**ISSUE:** Permit to Demolish (partial) and Certificate of Appropriateness for alterations (addition)

**LOCATION:** Old and Historic Alexandria District  
729 South Pitt Street

**BAR#2024-00222 & BAR#2024-00234**  
**729 S Pitt Street**

The applicant requests a Permit to Demolish (partial) and a Certificate of Appropriateness to build a porch addition above the first floor of the rear addition of the house.

*Figure 2. Proposed rear (west) elevation.*

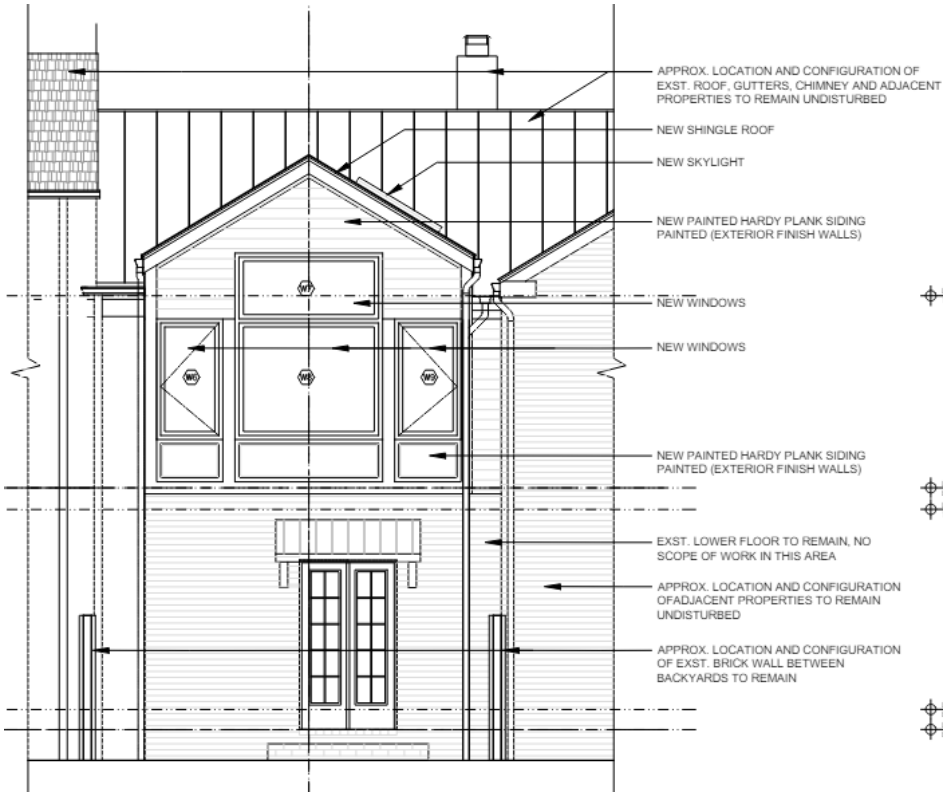
Overall, staff finds the new addition appropriate and recommends approval of the Permit to Demolish (partial) and Certificate of Appropriateness, with the following conditions:

- The applicant must work with staff to submit window specifications that comply with the guidelines found in the *BAR Policies for Administrative Approval*.
- The roof of the new addition must use architectural composition shingles, rather than 3-tab shingles.
